Economic Commission for Europe**Inland Transport Committee****World Forum for Harmonization of Vehicle Regulations****Working Party on Lighting and Light-Signalling****Seventy-ninth session**

Other Regulations:**Regulation No. 10 (Electromagnetic compatibility)****Proposal for the 06 series of amendments to Regulation
No. 10 (Electromagnetic compatibility)****Submitted by the Task Force on Electromagnetic Compatibility (TF
EMC)***

The text reproduced below was prepared by TF EMC with the aim to make Regulation No. 10 consistent with the International Special Committee on Radio Interference (CISPR) 12 Standard vehicle narrow-band limit and the last CISPR 12 set-ups (artificial networks, harness location, Z-folding, ...) for vehicles in charging mode. It also includes precision for vehicle in charging mode operating conditions (alternative or direct current charging). The modifications are marked in bold for new or strikethrough for deleted characters.

Figure 1
Vehicle in configuration "REESS charging mode coupled to the power grid"
Example of test setup for vehicle with plug located on vehicle side

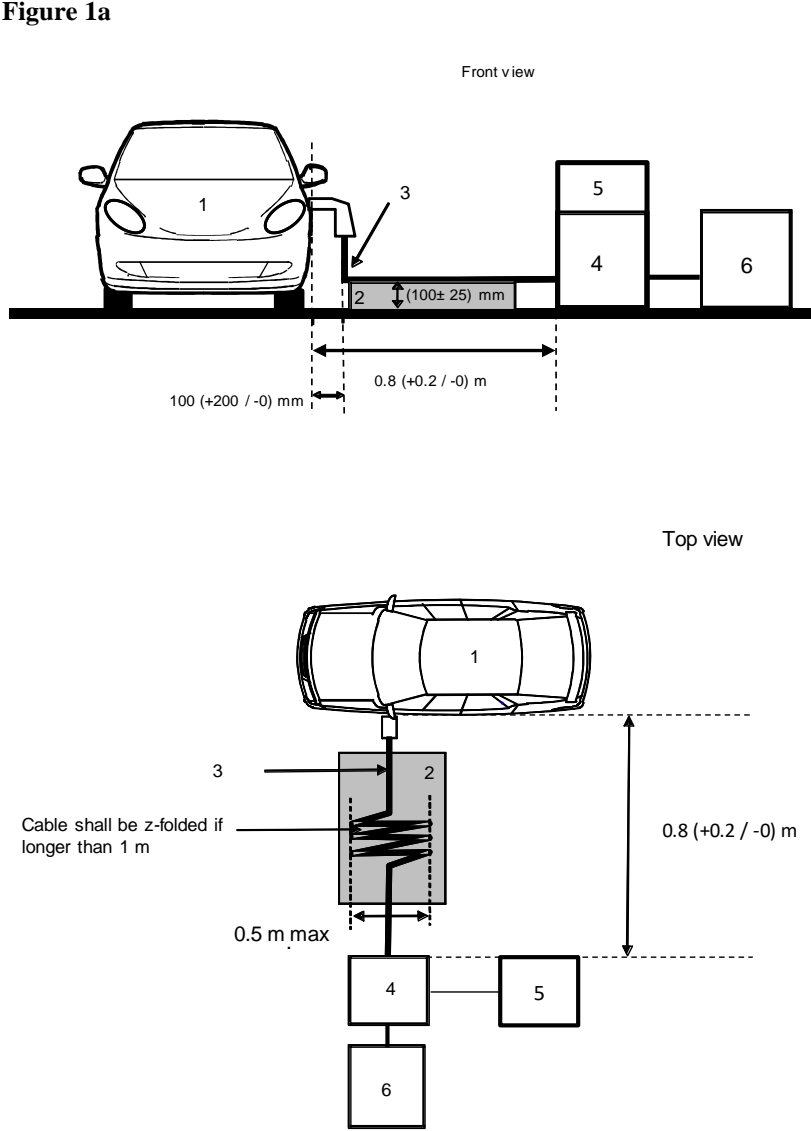
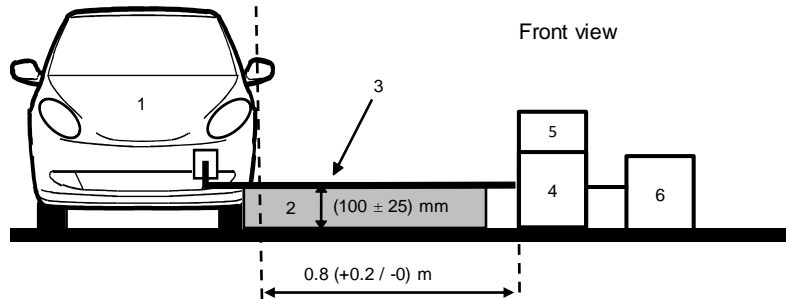
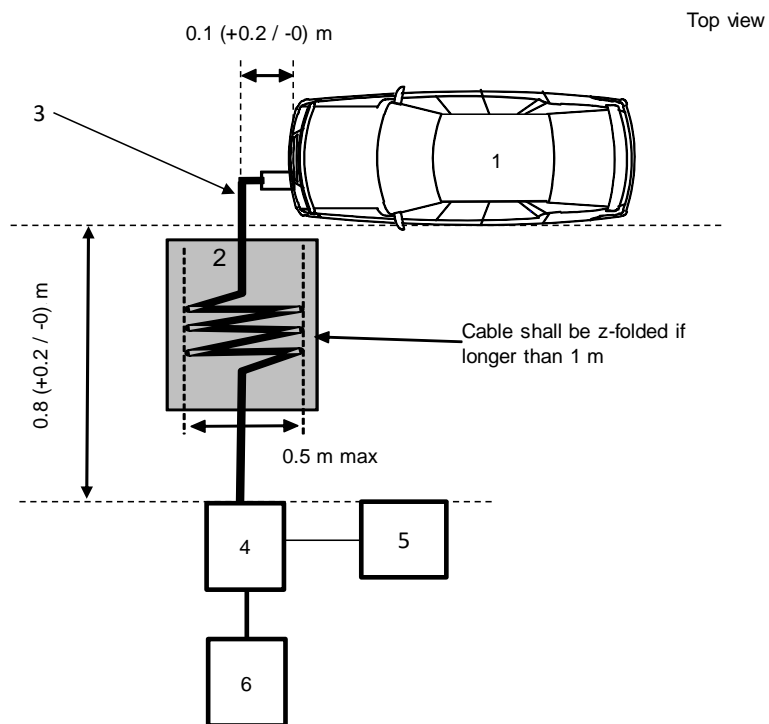
The vehicle shall be positioned on the ground plane. The electrical fast transient/burst (EFT/B) shall be applied on the vehicle on the AC/DC power lines in common modes by using CDN as described in Figure **1a to 1d** of Appendix 1 to this annex.

Figure 1

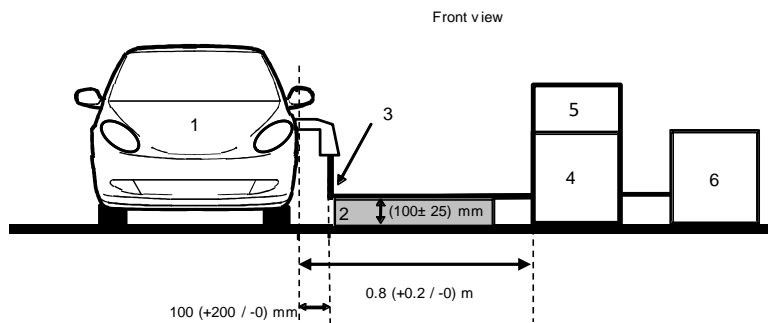
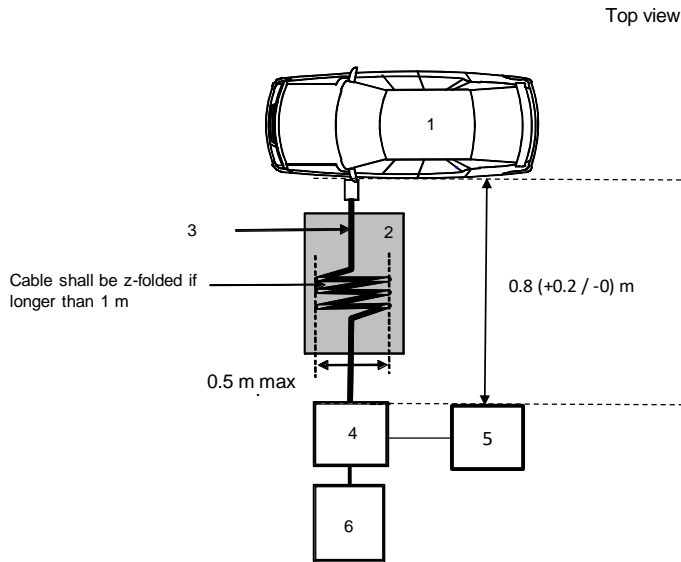
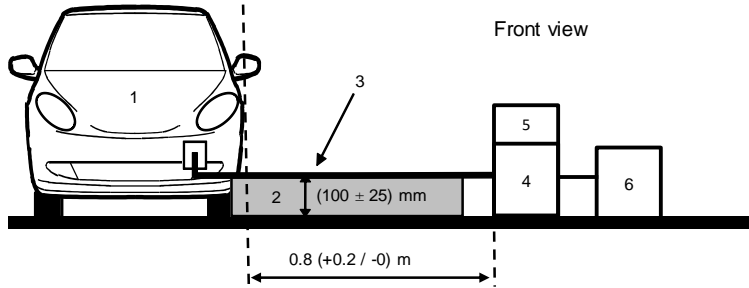
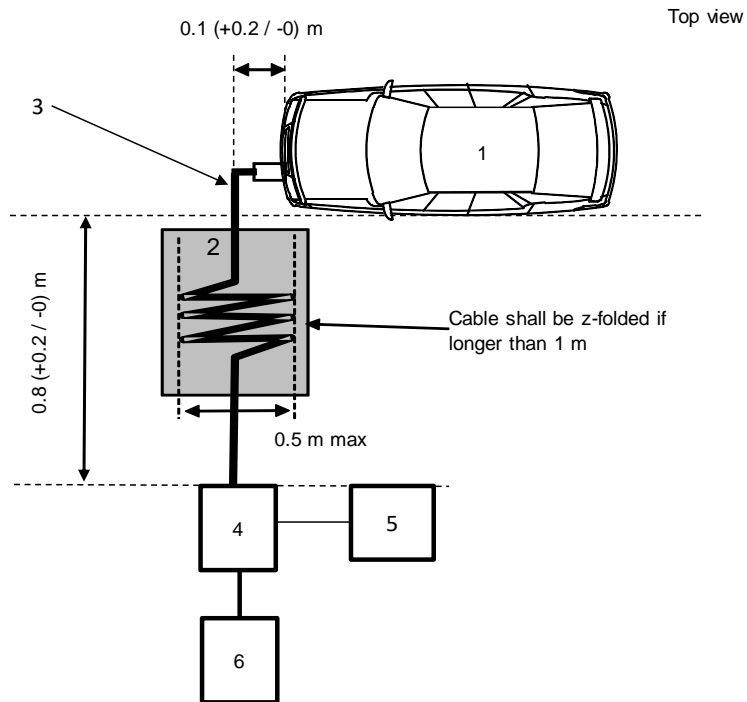
The vehicle shall be positioned on the ground plane. The electrical surge shall be applied on the vehicle on the AC/DC power lines between each line and earth and between lines by using CDN as described in Figures **1a** to **1d** of Appendix 1 to this annex,

Figure 1
ESA in configuration "REESS charging mode coupled to the power grid" (floor-standing equipment)

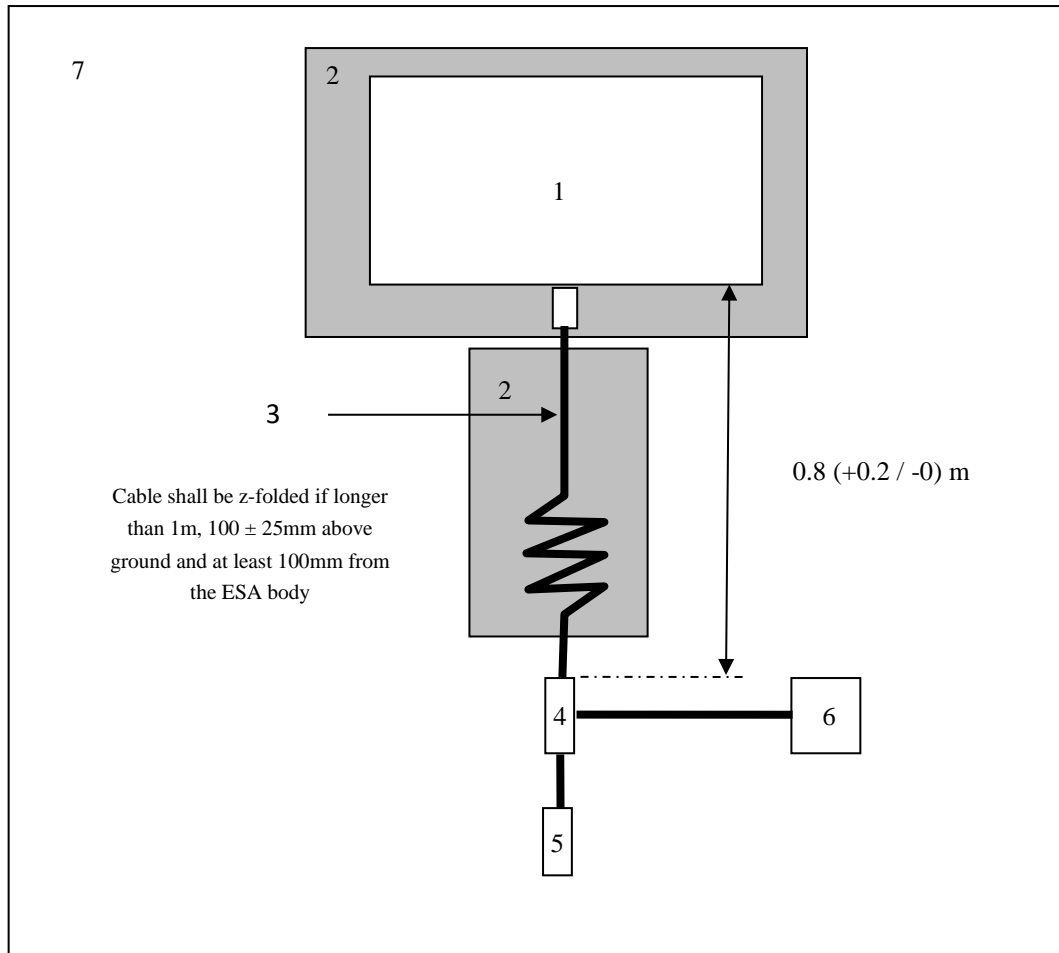
“3.3. The test set-up (**floor-standing equipment**) for the connection of the ESAs in configuration "REESS charging mode coupled to the power grid" is shown in Figure 1 of Appendix 1 to this annex.”

Figure 1
ESA in configuration "REESS charging mode coupled to the power grid" (floor-standing equipment)

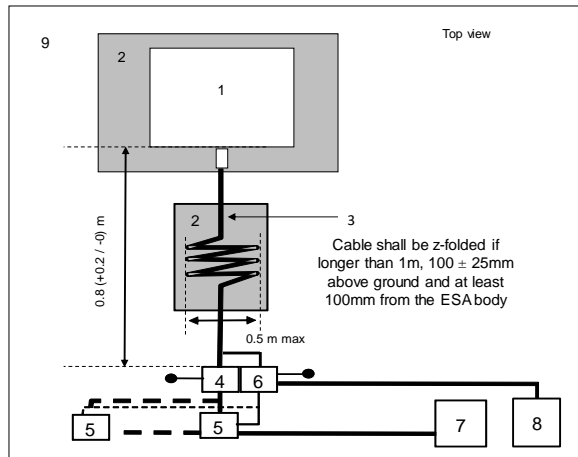
“3.3. The test set-up (**floor-standing equipment**) for the connection of the ESA in configuration "REESS charging mode coupled to the power grid" is shown in Figure 1 of Appendix 1 to this annex.”
